VOB Development, Sketch Plan No. 320190040 & Preliminary Plan No. 120190160

Completed: 5/20/2019

Sketch Plan No. 320190040

Preliminary Plan No. 120190160

Figure 17 – Proposed Grand Park Avenue Section

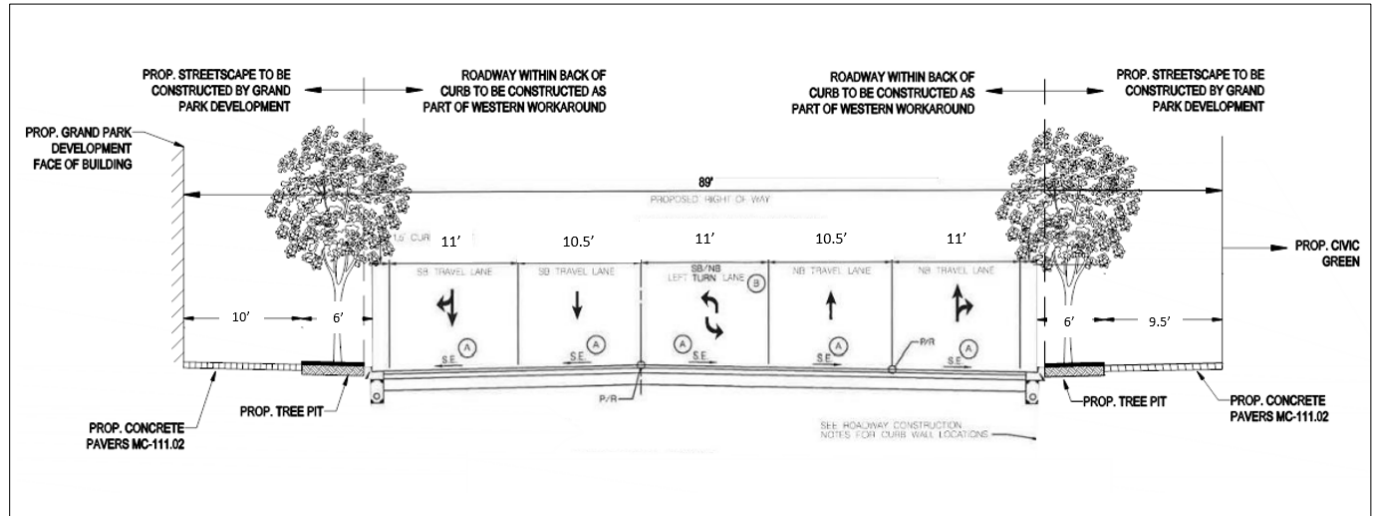
The *Bicycle Master Plan* recommends separated bike lanes on the segment of Grand Park Avenue adjacent to the Property but has not yet designated a side for the facilities. The White Flint Recreation Loop, a signed or marked loop, also falls along this segment. The Applicant proposes to maintain recommendations for the vehicular travel lanes that are consistent with the WFWW plans. Beyond the vehicular travel lanes, the WFWW plans call for ten (10)-foot-wide shared-use paths on either side of the future street. The Applicant proposes a ten (10)-foot-wide paver-sidewalk on the west side of the property and a nine and a half (9.5)-foot-wide paver sidewalk on the east side of the property adjacent to the proposed civic green. Because pavers are not ideal for bicycle travel, Staff will coordinate a Site Plan with the Applicant on a design for the facility adjacent to the park, which improves bicycle

circulation and meets the intent of the *Bicycle Master Plan* and the planned White Flint Recreation Loop. Figure 17 shows the Applicant's proposed section for Grand Park Avenue.

Figure 18 – Proposed Grand Park Avenue Section – Parking Option

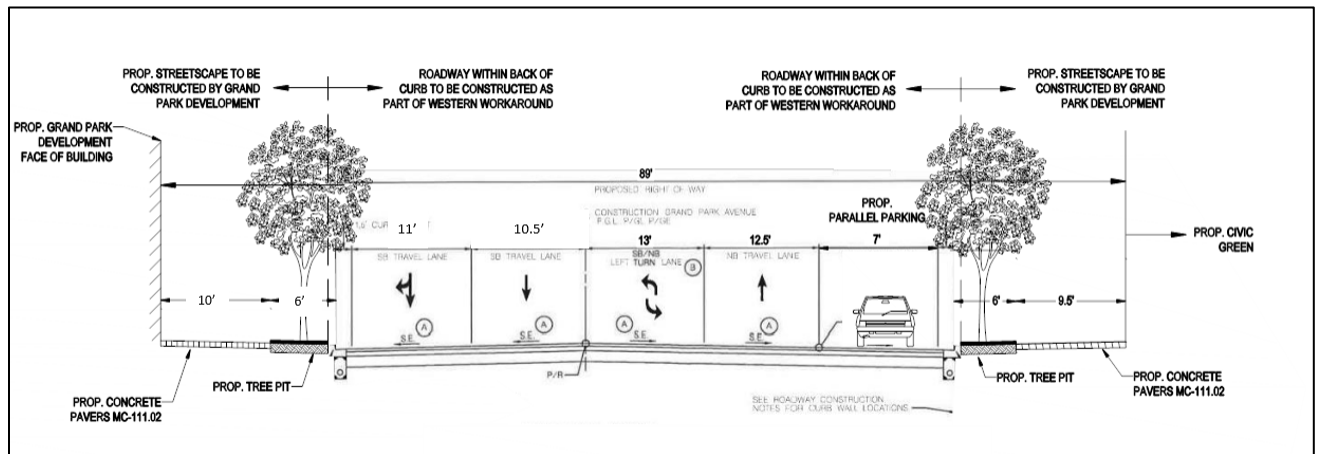
The WFWW's sections were developed based on previous land use and capacity assumptions. Planning Staff suggests that the Grand Park Avenue streetscape and adjacent uses could be better served by reducing travel capacity and integrating vehicle parking. While changes to the WFWW plans would require an operational analysis—which cannot be accommodated by MCDOT at this time—the Applicant has provided a conceptual roadway section option for future consideration at subsequent Site Plan(s), which integrates parking adjacent to the proposed park. This alternative section adds additional separation between the future recreation loop and the vehicular travel lanes, as shown in Figure 18.

Figure 20 – Circulation Plan

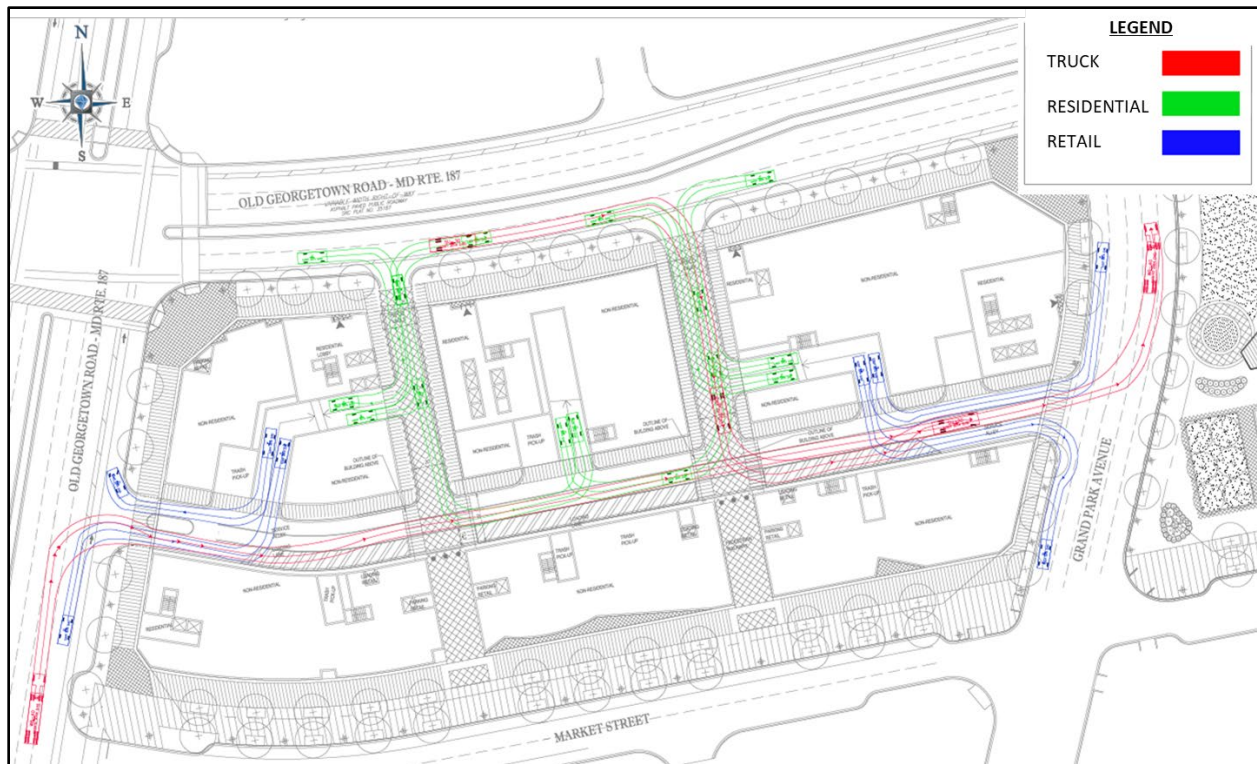
The location of building entrances impacts street aesthetics and activity. Staff prefers that building entrances be located at the grade of adjacent sidewalks and that any elevation change to meet floorplates be accommodated internally. While this preference may reduce the efficiency of the Applicant’s buildings, it conversely improves the public realm and experience of adjacent streets. Staff is particularly interested in building entrances along Market Street, a primary walking street, and the east-west segment of Old Georgetown Road, which has issues related to grade change. The Applicant and Planning Department Staff will continue to work toward acceptable designs when more detail is provided during Site Plan review. To facilitate the development of acceptable designs, Staff recommends that all building entrances on the east-west segment of Old Georgetown Road and Market Street to be provided at the elevation of the adjacent sidewalk. The proposed condition language prohibits sunken or elevated portions of sidewalk within public space.
